ADDENDUM 1

DATE: April 18, 2024

PROJECT: OUSD, Wagner Ranch Elementary School Path of Travel Work

FROM: HKIT Architects

9 LOT 2 - ACCESSIBLE PARKING DEMOLITION PLAN
1/4" = 1'-0"

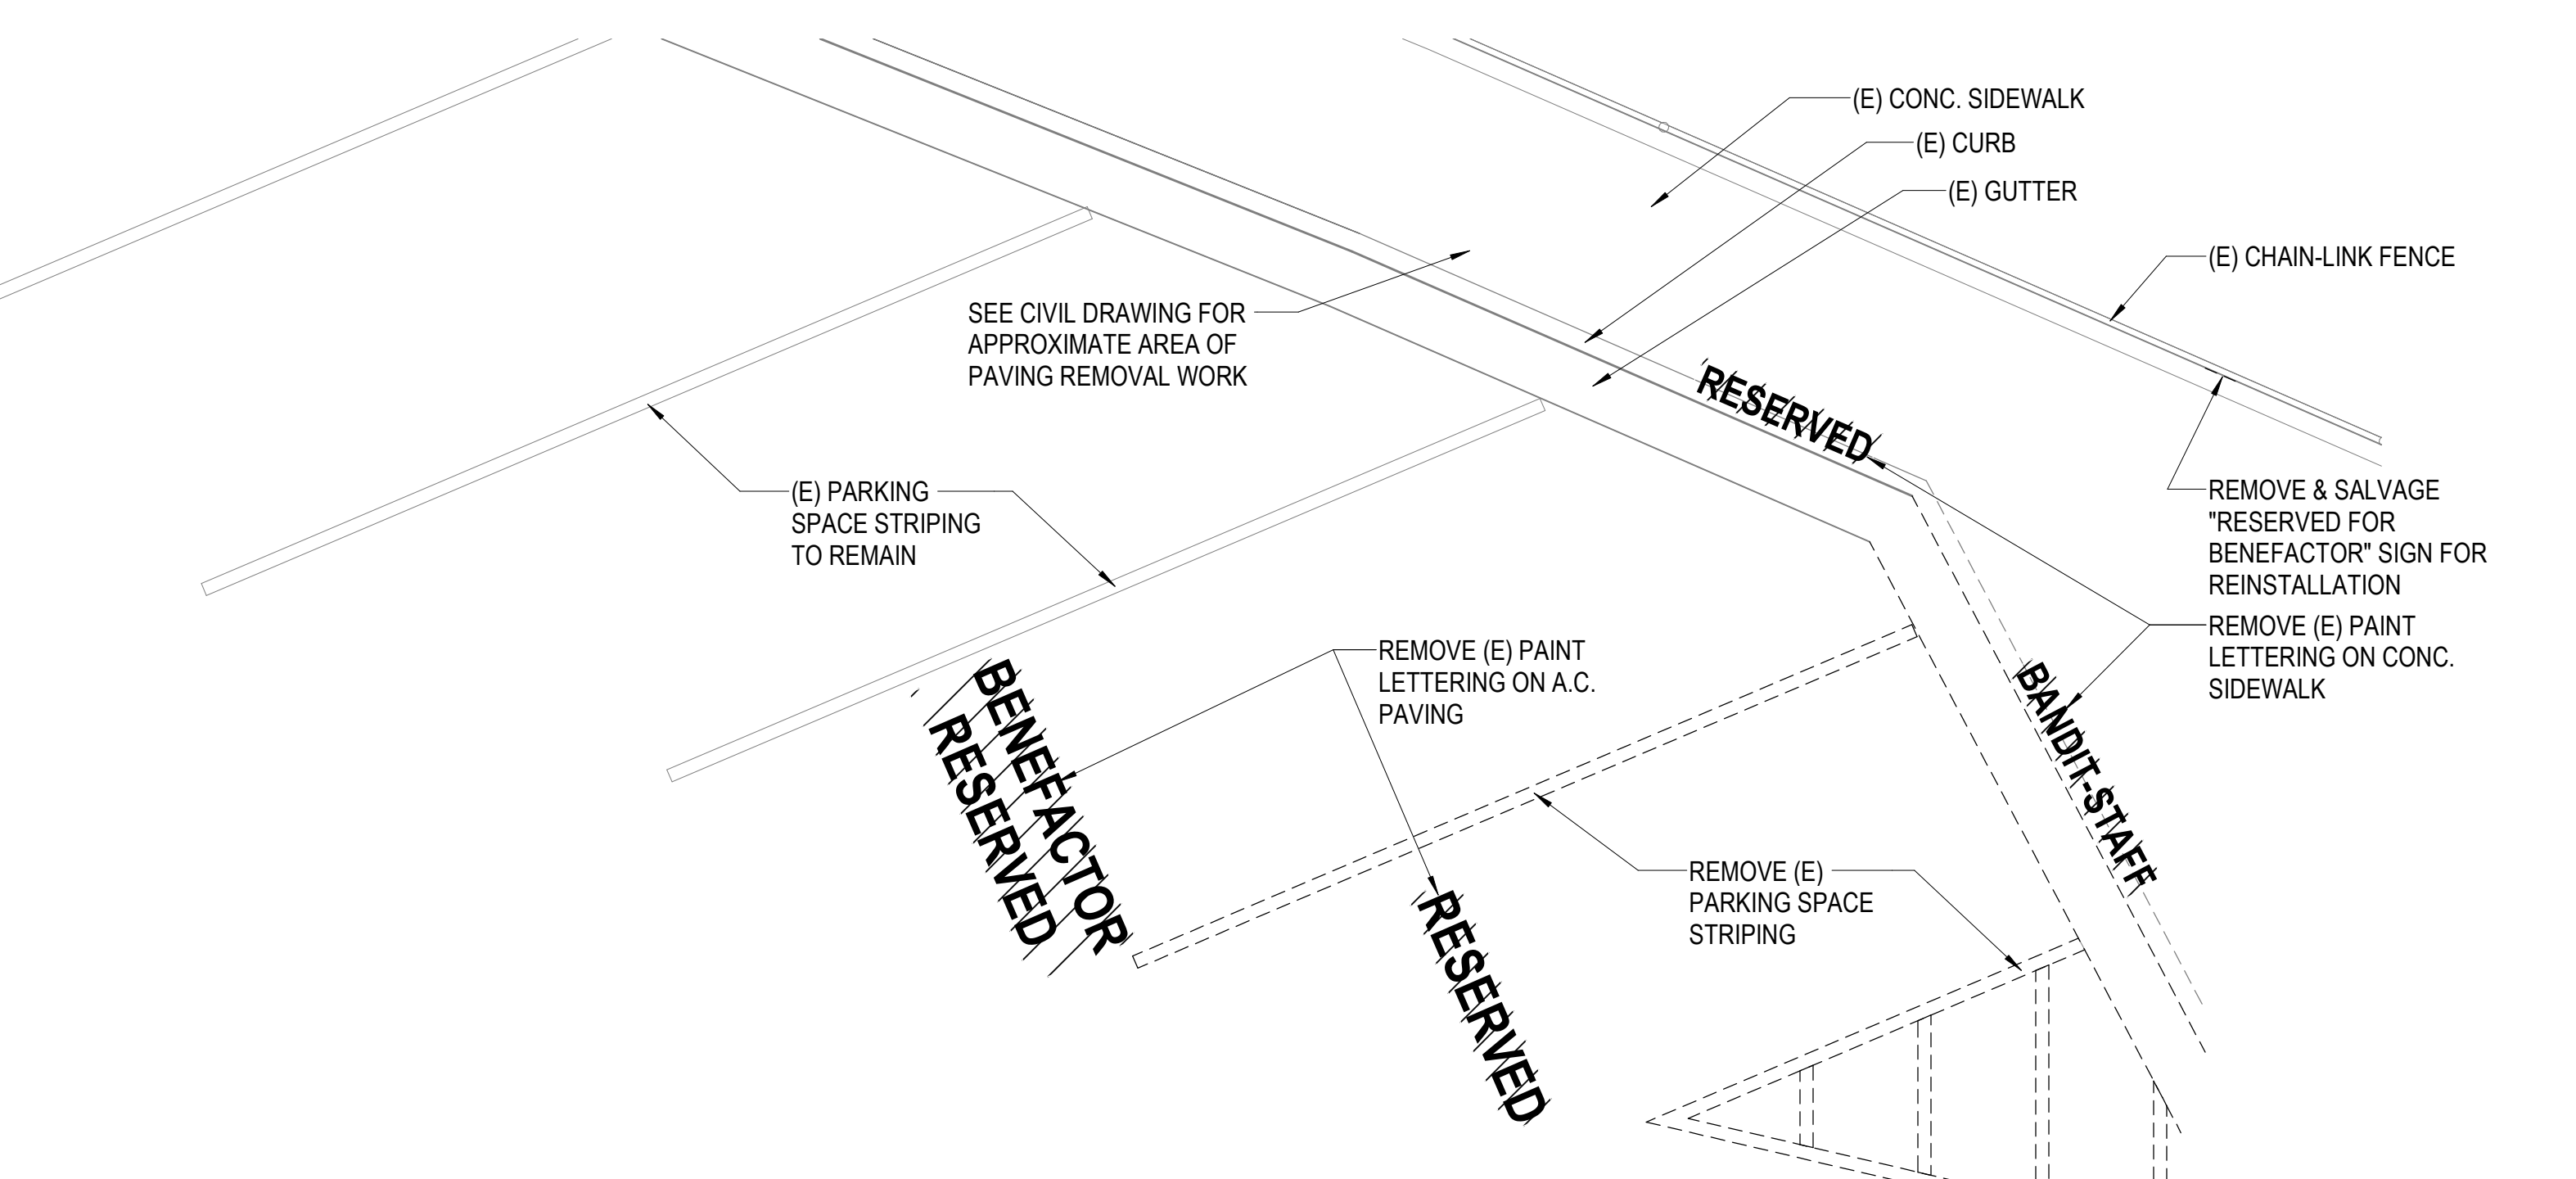
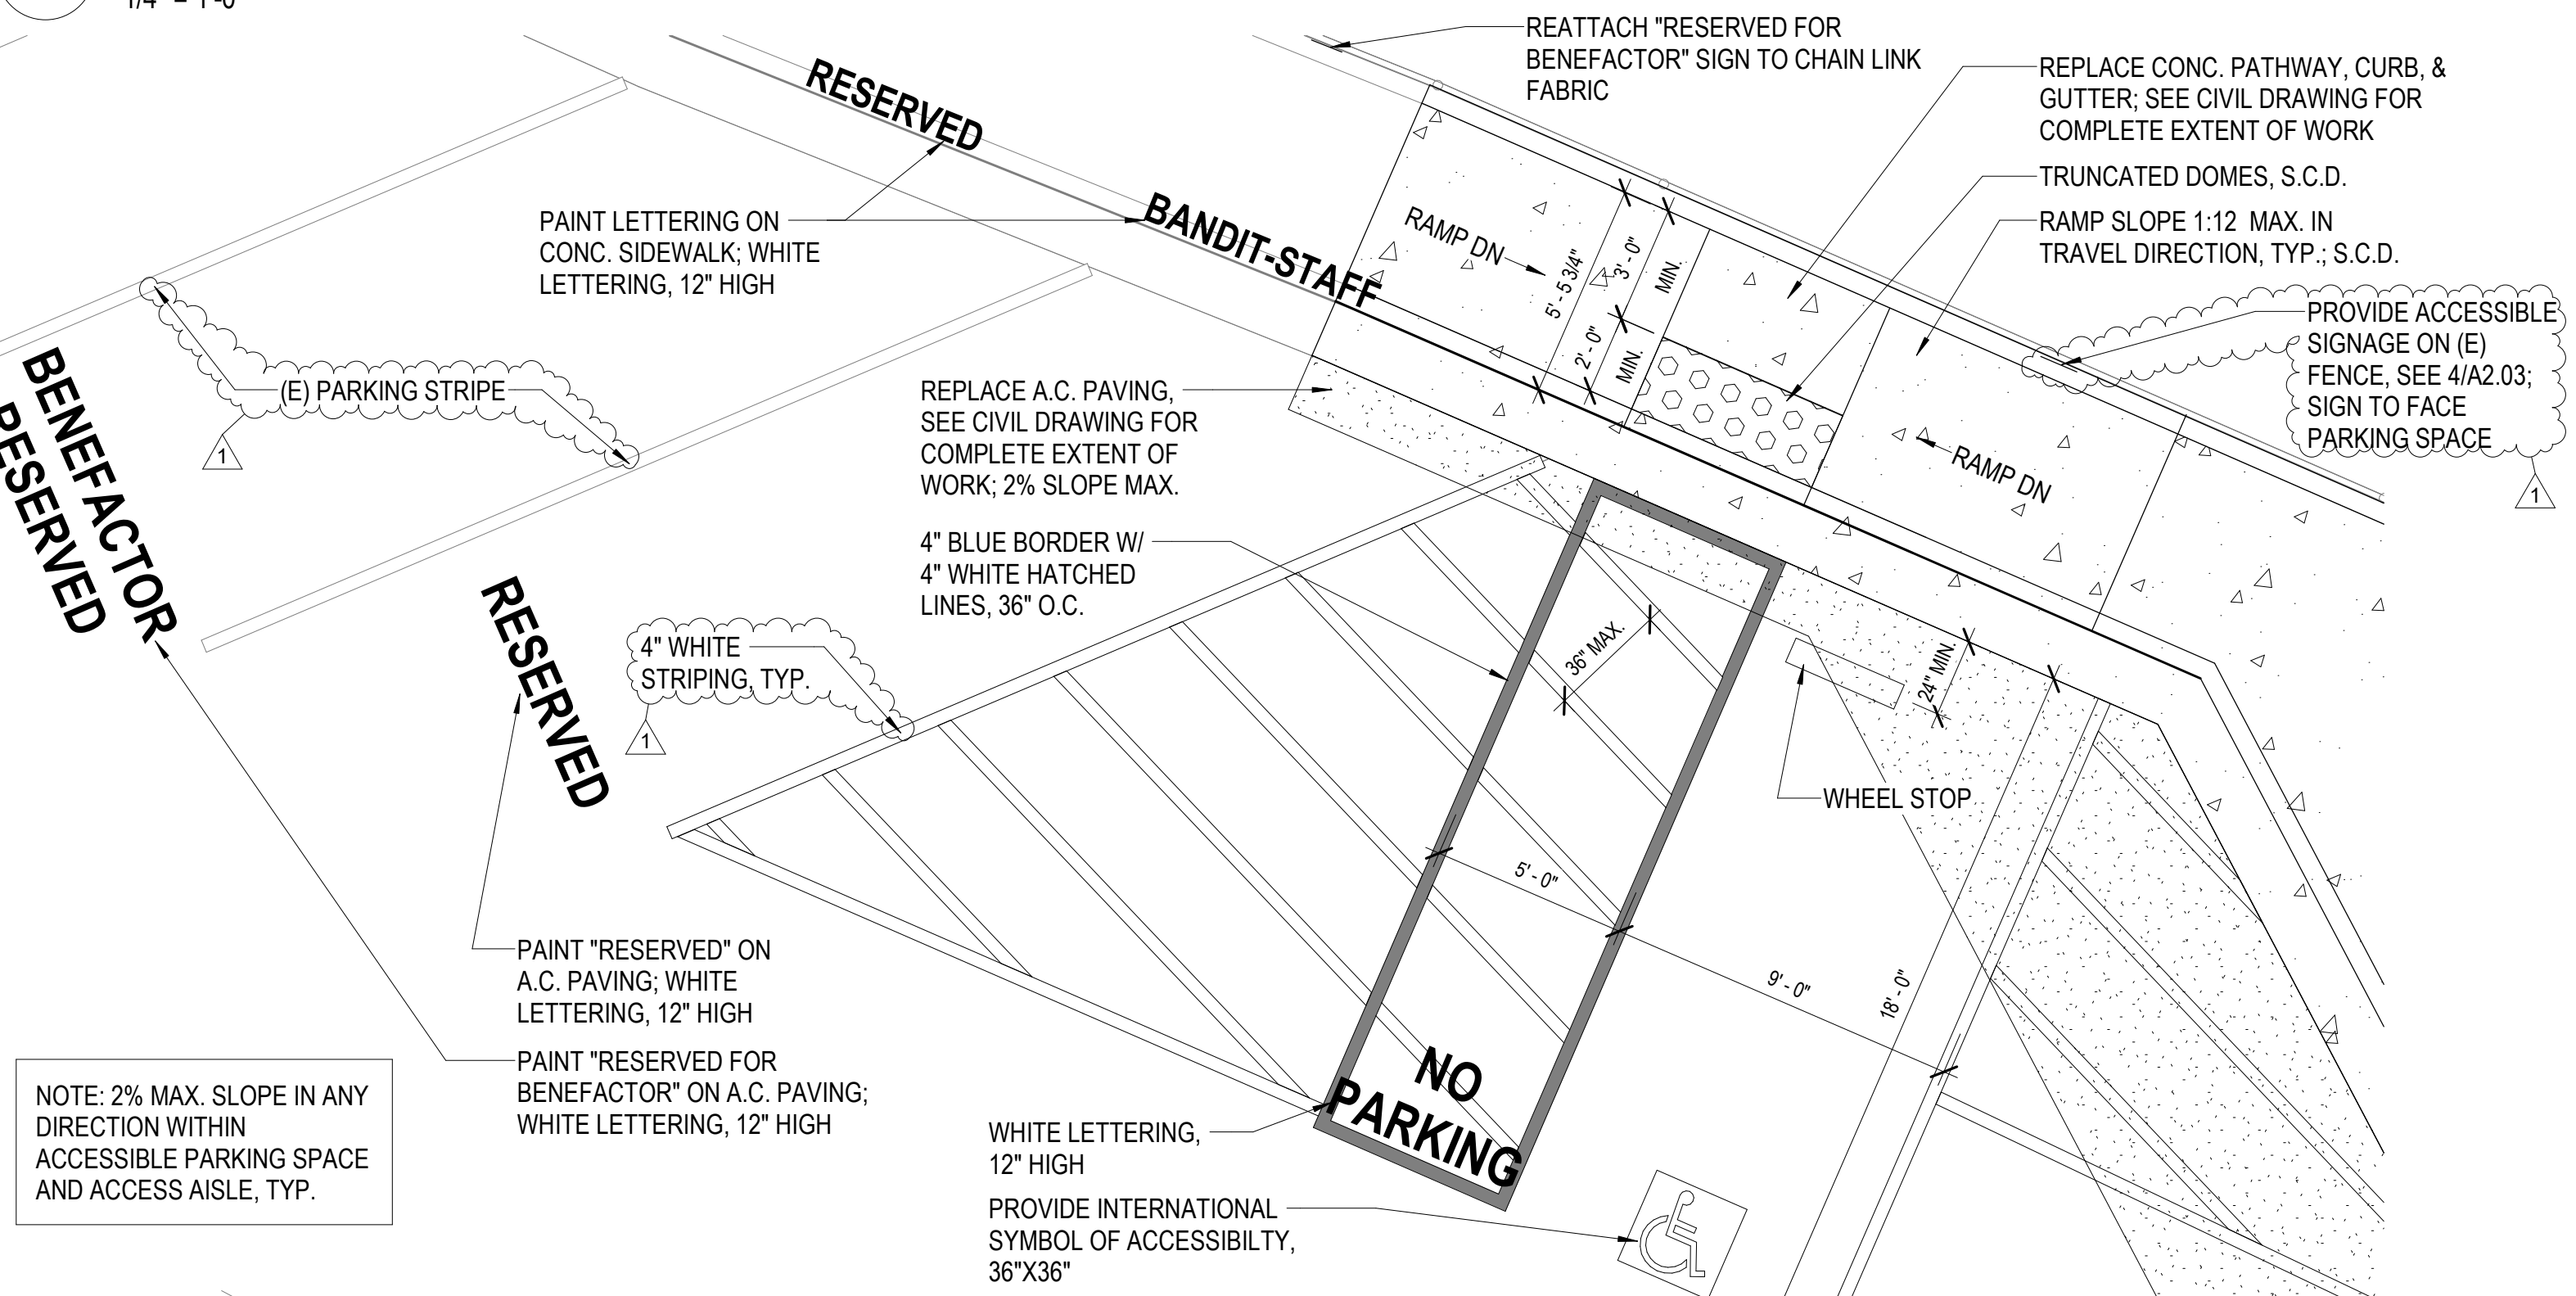
1-2 Subject: Truncated domes at curb ramps.

Description of Change: Truncated domes should be cast-in-place.

2 (E) ACCESSIBLE DRINKING FOUNTAIN
1" = 1'-0"

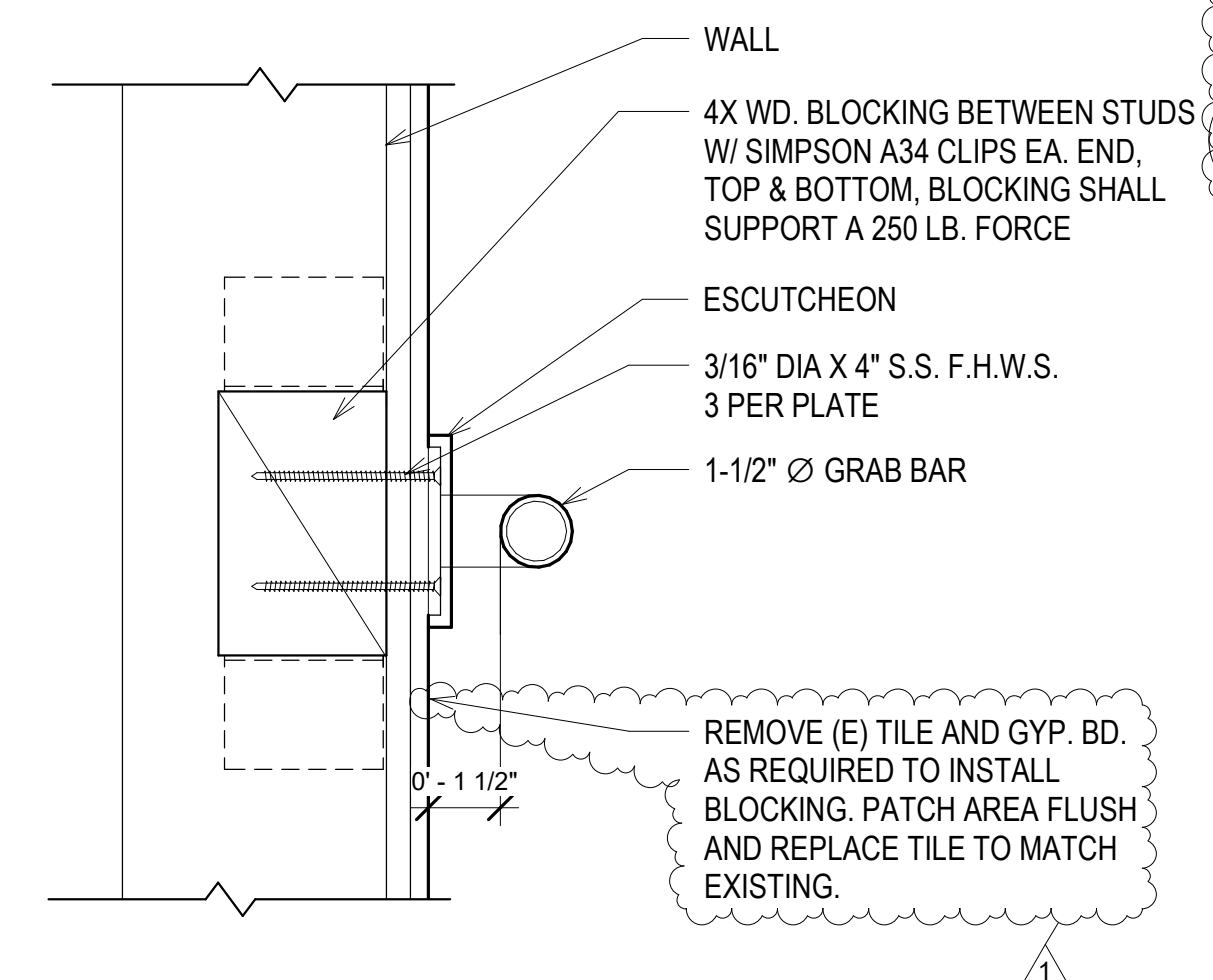
1. Can you clarify what is being done with the drinking fountain. When I attended the initial job walk, I seen a fountain on the exterior of the building, the plans show it is on the interior. Is it being replaced is there an existing fountain in its place?

ANSWER: The drinking fountain shown in Building 500 is the DSA approved location on the path of travel. It is existing to remain, no scope of work at this drinking fountain. It is shown for DSA approval of path of travel and will be reviewed by the IOR for conformity to plans.

12 GRAB BAR ATTACHMENT
3" = 1'-0"

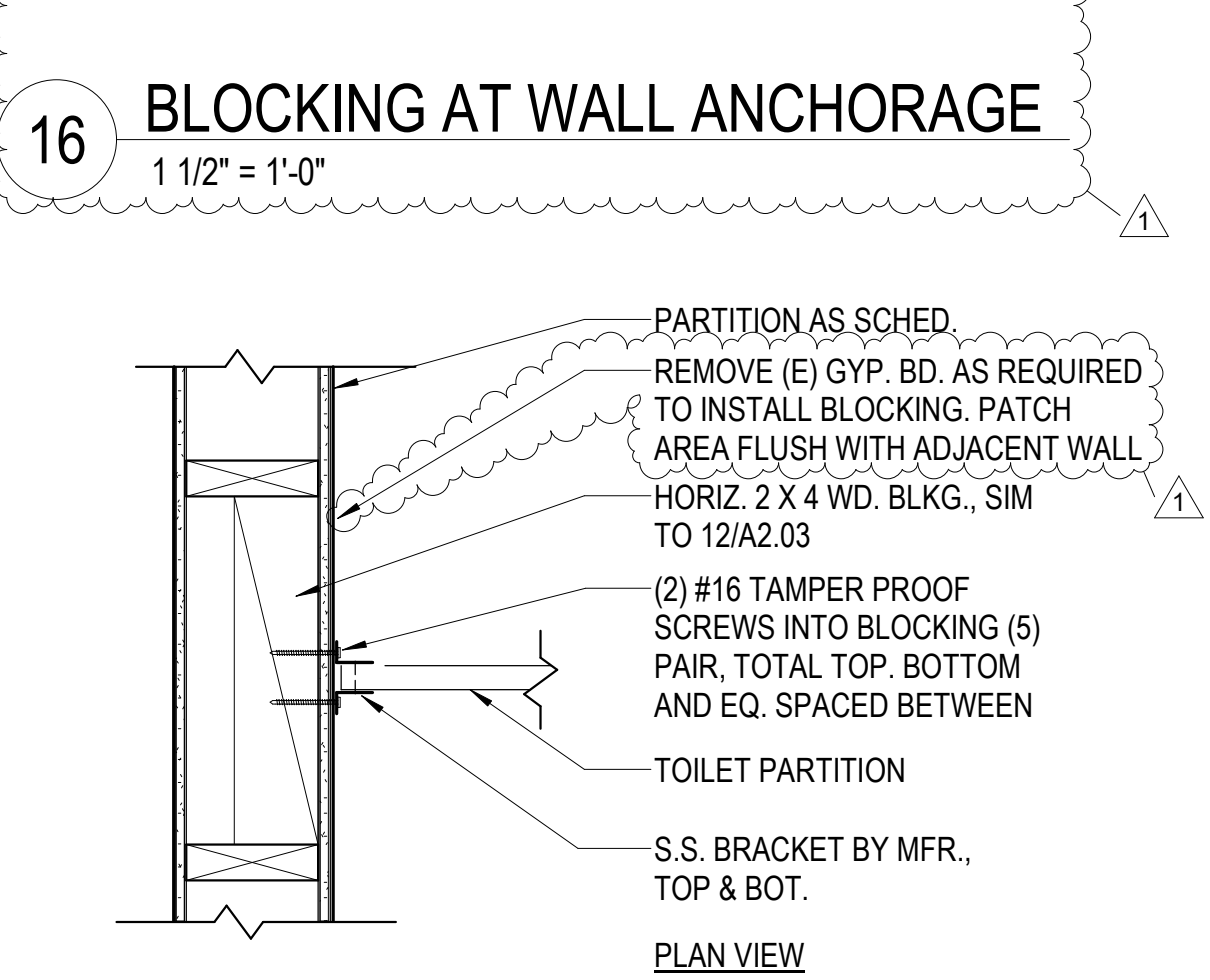
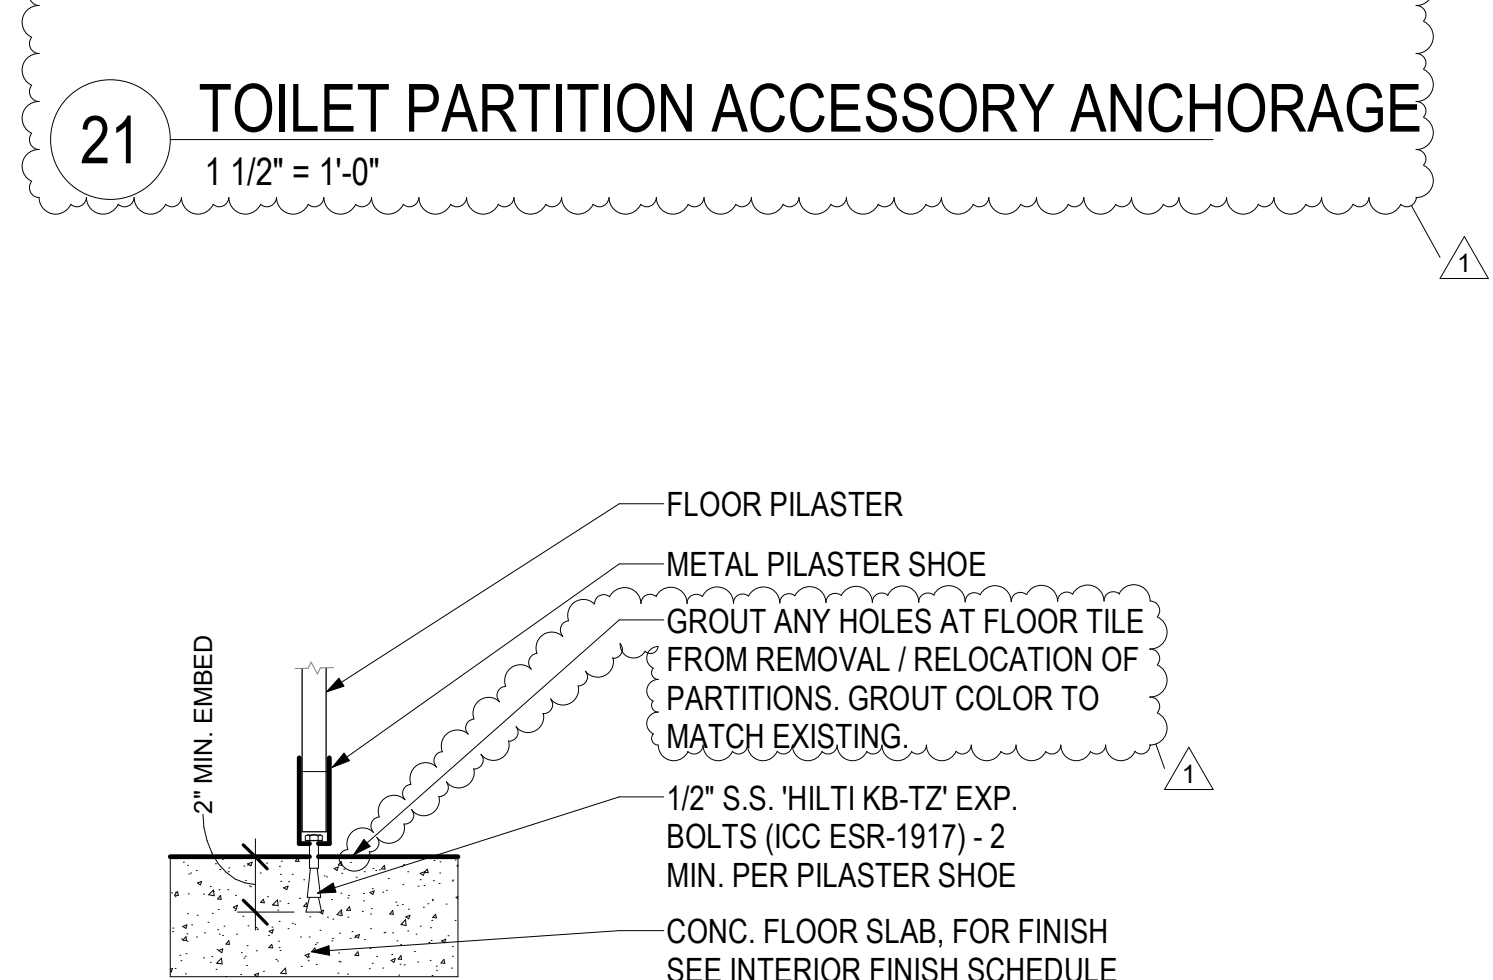
Description of Change: Provided additional dimensions and keynotes to clarify scope and required changes to toilet rooms. Revised blocking details for accessories and grab bars at A2.03
